Bulletin No.: PIP6008C
Published date: 01/24/2025

PIP6008C 10L80 DTC P2714

Product Investigation Review Required

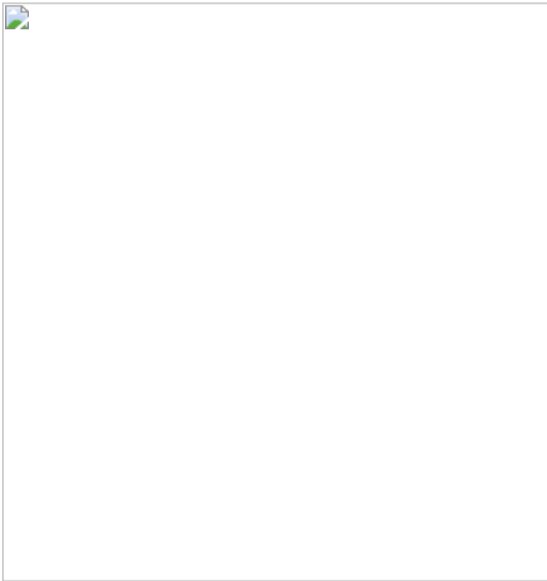
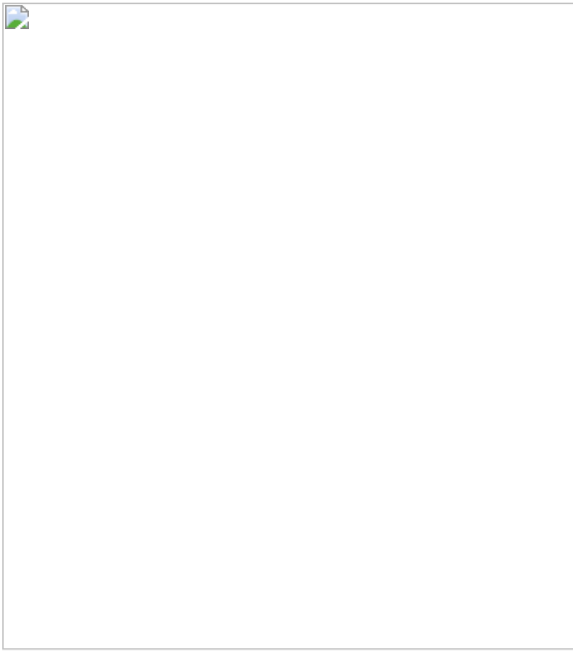
Sample above, S3240462BKJX0090 is:

Plant built location, "S" Silao.

Julian Date, "24046", 46th day of Calendar year 2024.

*** Suspect transmission assemblies serial number will start with "R" as a Romulus build. ***
